**Re: Review of (revised) Non-Time-Critical Removal Action Work Plan**  
Closed Loop 59<sup>th</sup> Avenue Warehouse  
435 South 59<sup>th</sup> Avenue, Suite 120 and 130  
Phoenix, Arizona 85043  
VRP Site Code: 513246-00

**Re: Review of Non-Time-Critical Removal Action Work Plan**  
Closed Loop 59<sup>th</sup> Avenue Warehouse  
435 South 59<sup>th</sup> Avenue, Suite 120 and 130  
Phoenix, Arizona 85043  
VRP Site Code: 513246-00

**Response To ADEQ Comments dated February 24, 2020**  
**Non-Time Critical Removal Action Work Plan**  
**Closed Loop 59<sup>th</sup> Avenue Warehouse**  
**435 South 59<sup>th</sup> Avenue, Suite 120 and 130**  
**Phoenix, Arizona 85043**  
**VRP Site Code 513246-00**

Removal Action Work Plan Cathode Ray Tube Material Non-Time-Critical Exterior Closed Loop 59th Avenue Warehouse 435 South 59th Avenue, Phoenix, Arizona 85043	
<b>Soil Characterization Sampling Location Map</b>	<b>FIGURE 5</b>

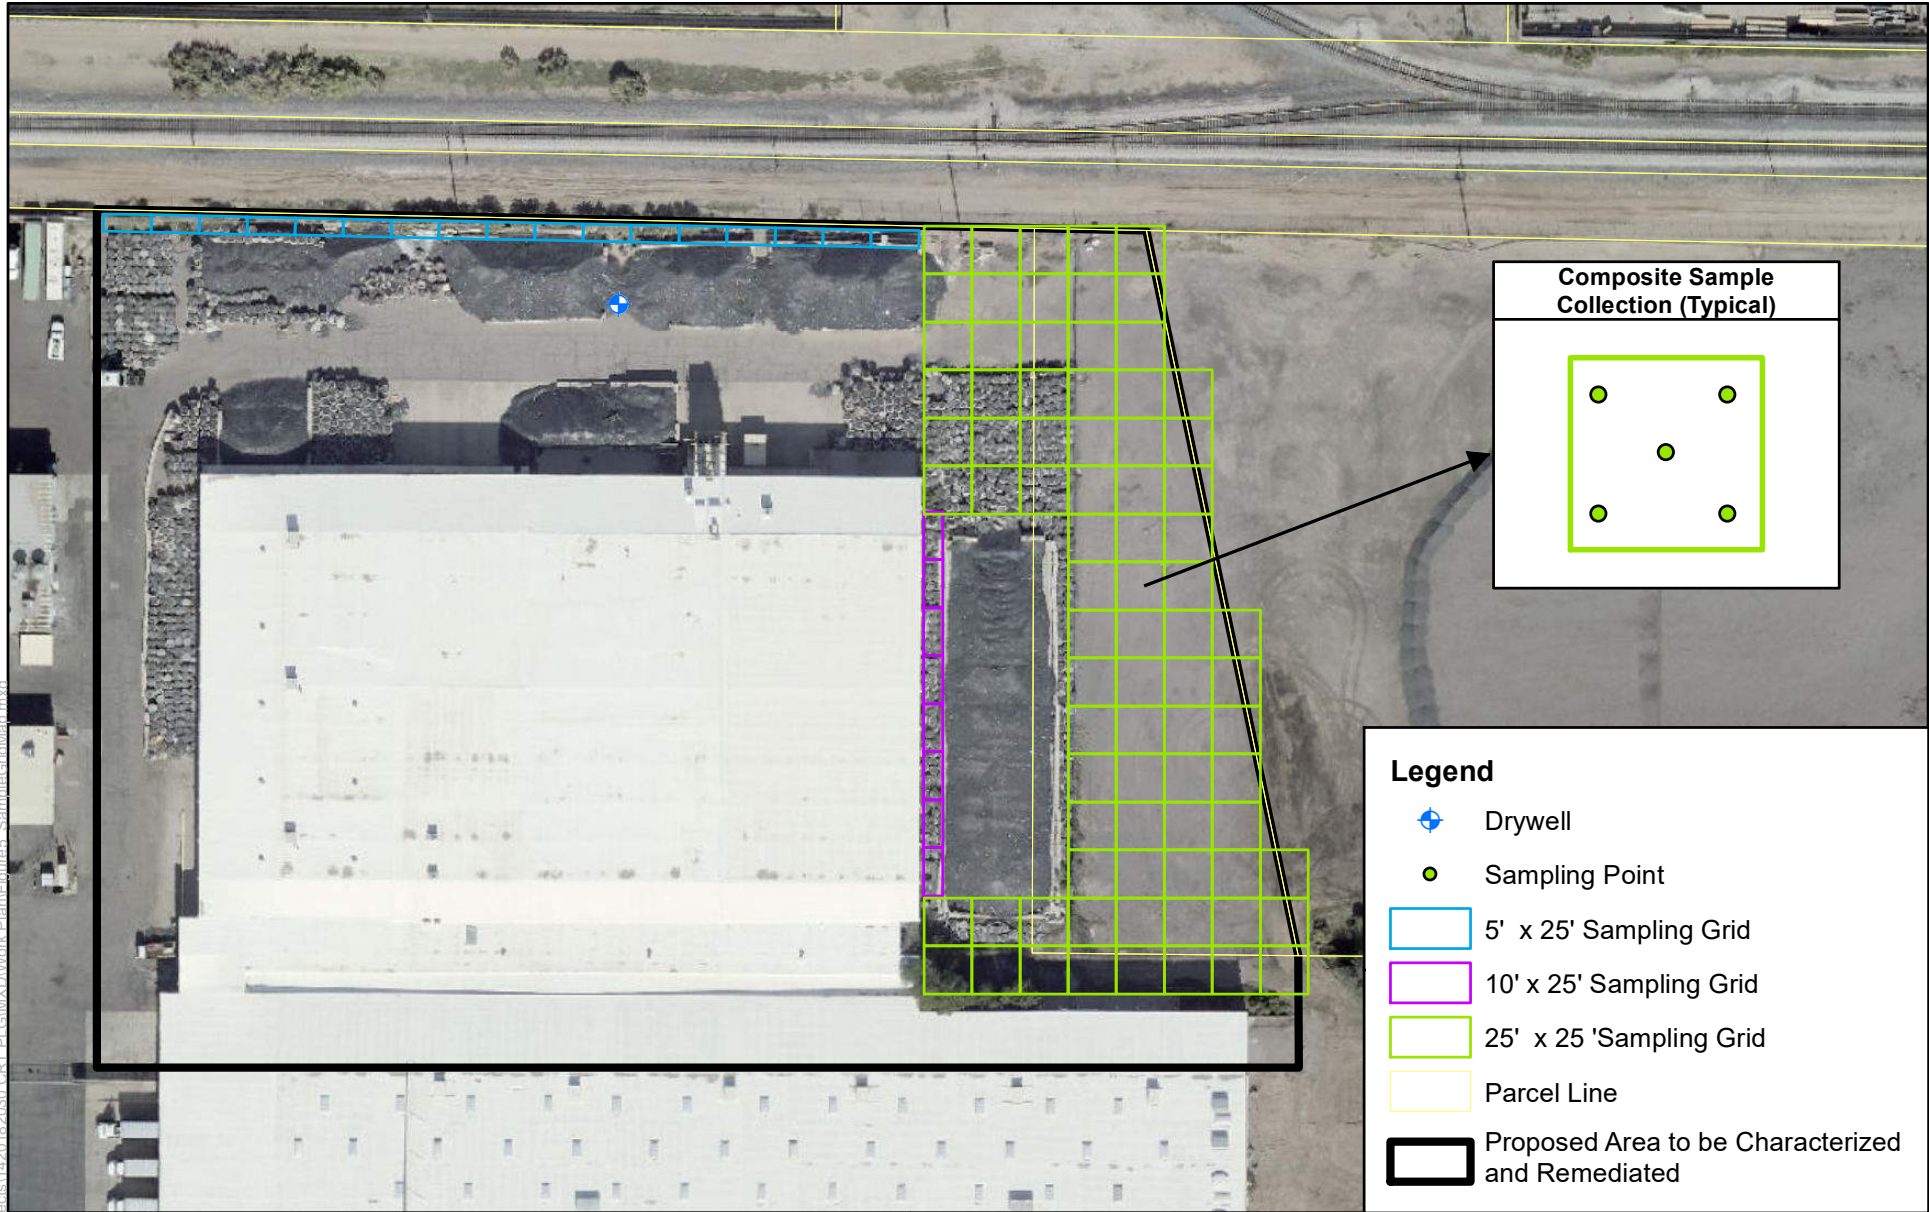
23. Please add drywell location(s) on Figure 5.

23		Figure 5	Please add drywell location(s) on Figure 5.	Figure 5 has been revised to include the location of the drywell.

8. During an inspection of the facility conducted by ADEQ on December 17, 2019, inspectors noted the presence of two drywells on-site; however, the Work Plan discusses only one. The ADEQ acknowledges the drywell represented on Figure 5, however inspectors noted what appears to be a second on the west side of the building. At the time of the inspection, the apparent drywell was submerged by water. Please refer to photo 3 of the enclosed inspection report. If this feature meets the definition of a drywell in accordance with Arizona Administrative Code (A.A.C.) R18-9-101(20), it must be registered with ADEQ prior to conducting any investigation, protected by the preventative measures described in Section 2.1.6, and sampled as described in Section 2.5.
